> Re: Richard and Nancy Morgan 608 Tower Bank Road Severna Park, MD 21409 T.M. 50 B. 24 P. 72 Complaint case# B-2023-188

Please accept this as our formal variance request to the Subdivision and Development Regulations in Article 17 on behalf of our client regarding critical area law. The variance requests are to Article 17, Section 8-201 to disturb steep slopes in the critical area.

CONFIRMATION OF PRE-FILE

The applicants are requesting the following variances to perfect the replacement of a retaining wall and water access steps with a tram platform greater than 36sqft (B02418296 to abate B-2023-188):

VARIANCE PLAN

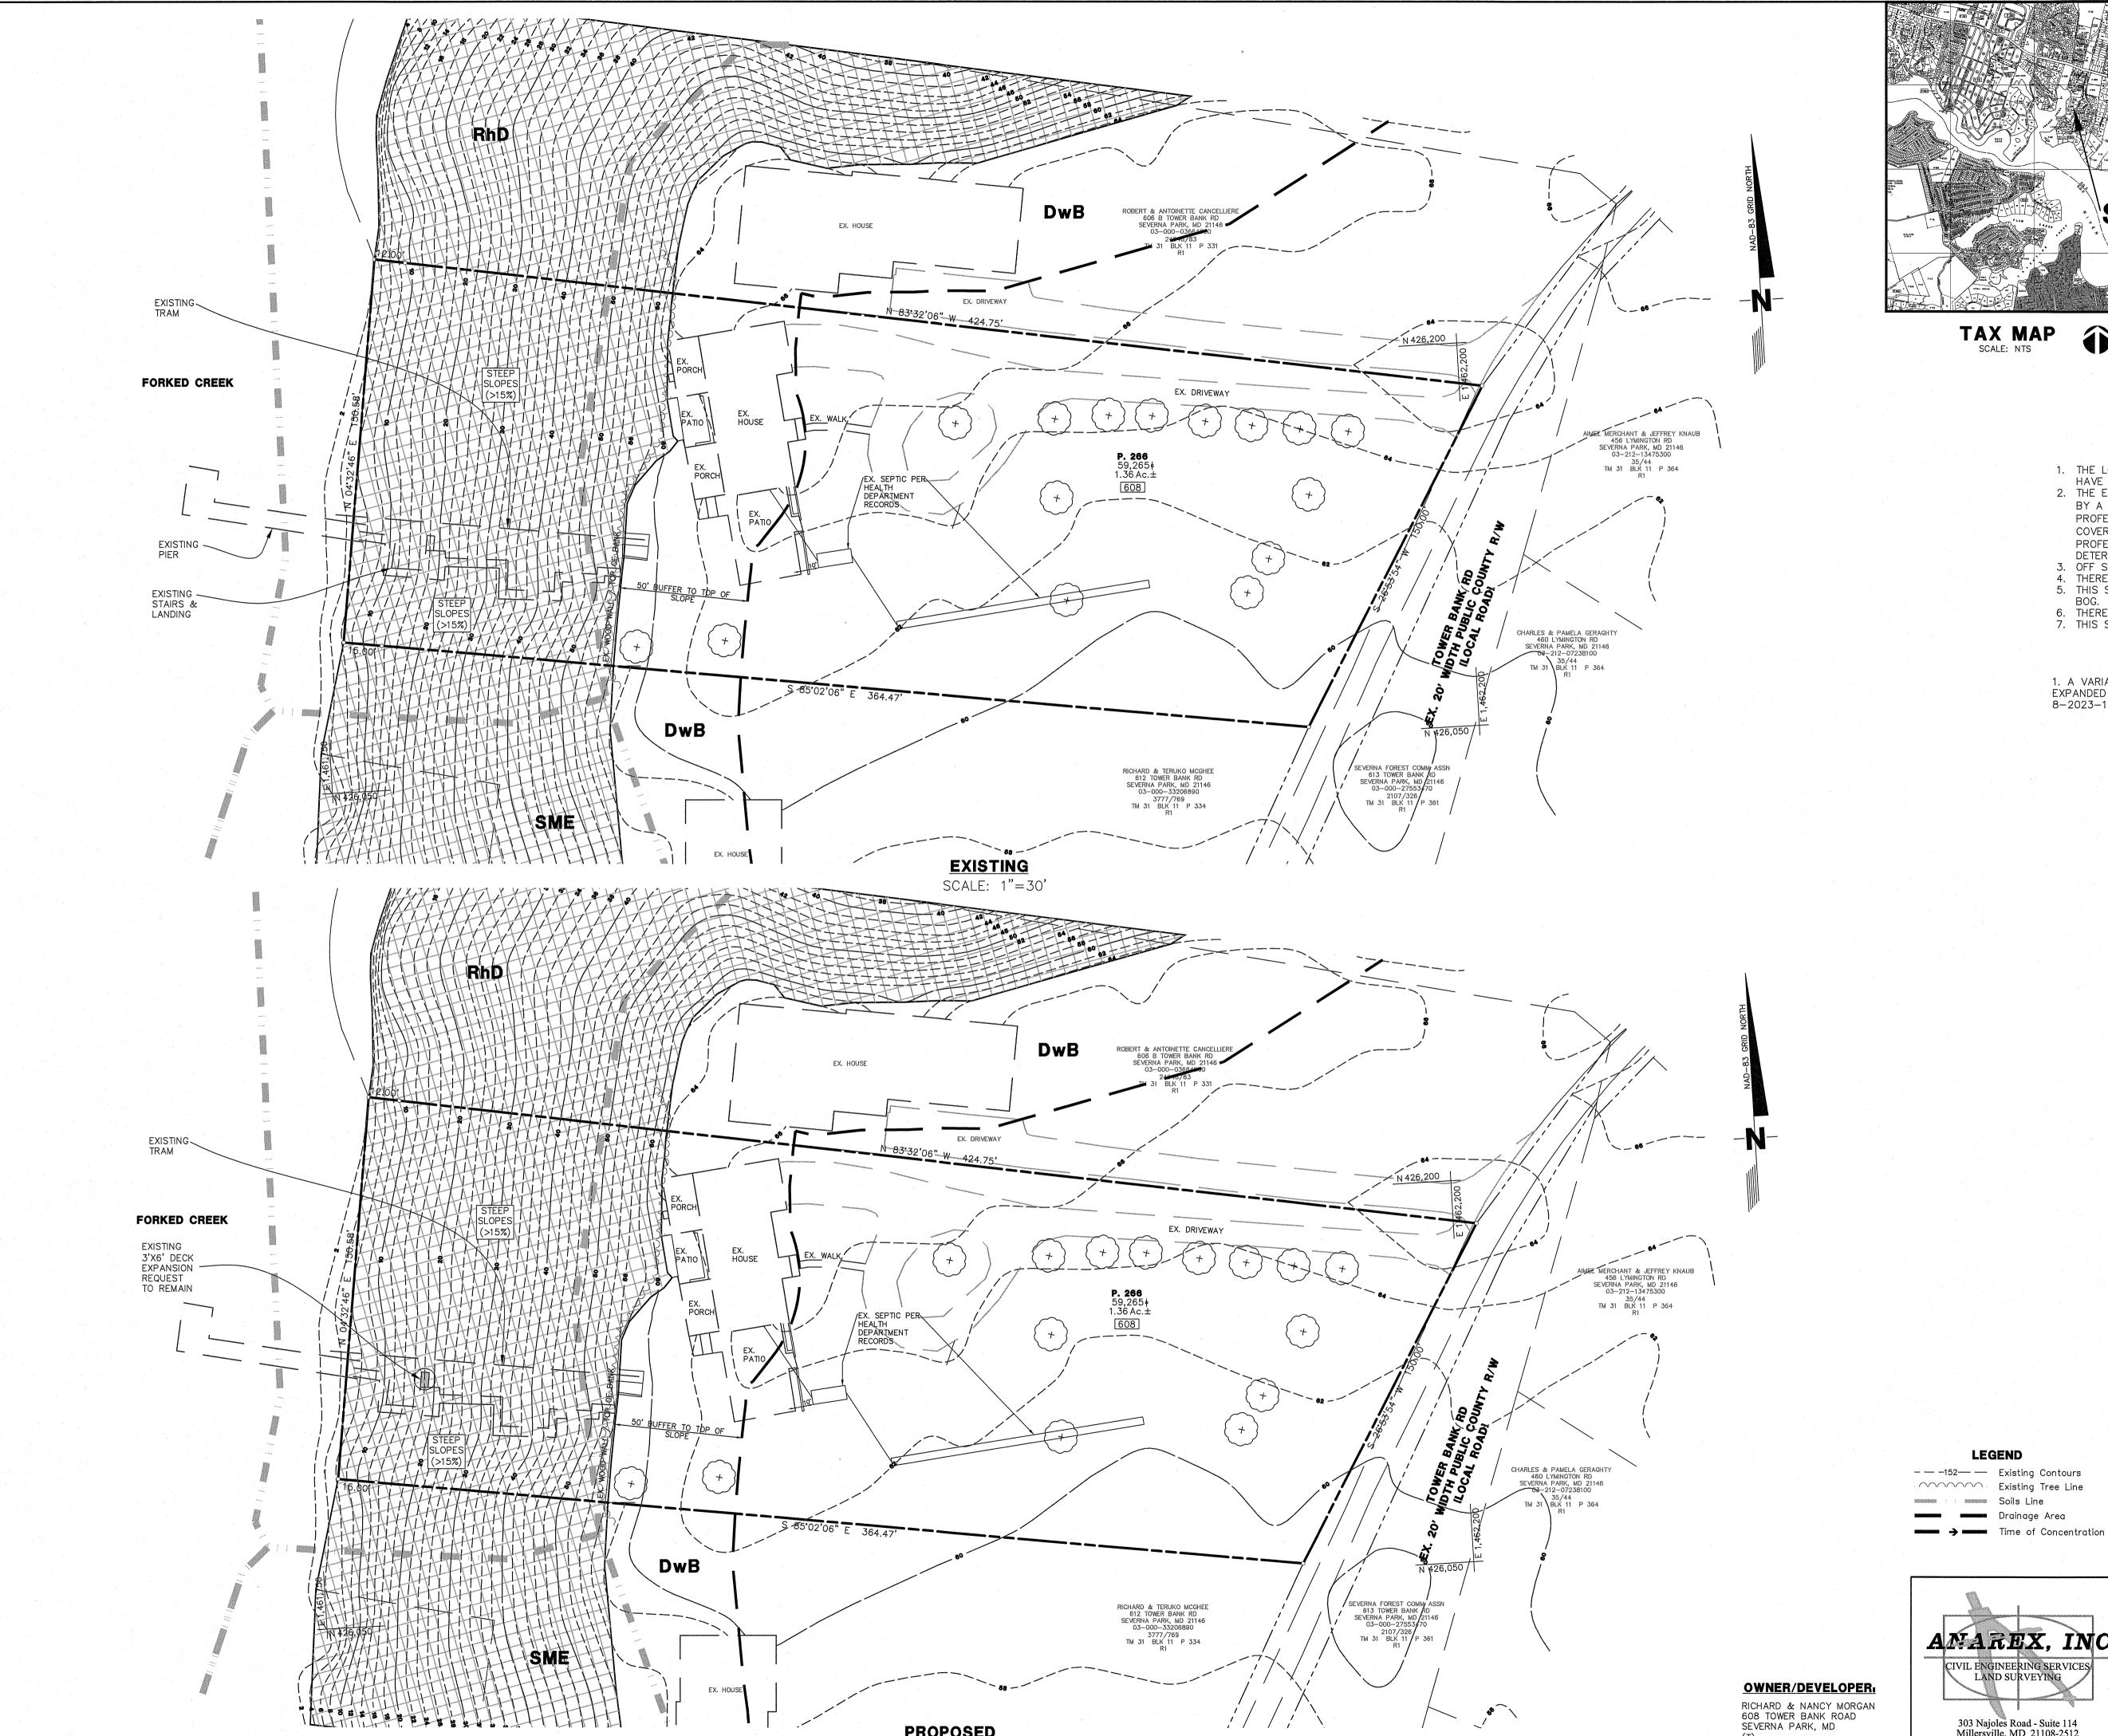
No objection to the replacement/repair of the steps and retaining walls.

Retaining wall locations should be clearly shown/labeled on the site plan.

Additional explanation/photos should be provided to justify the 3x6 platform.

The Letter of Explanation for the variance submission should reference the correct Code sections.

The Administrative Site Plan should clearly show the footprint of the retaining wall, water access steps and landings.
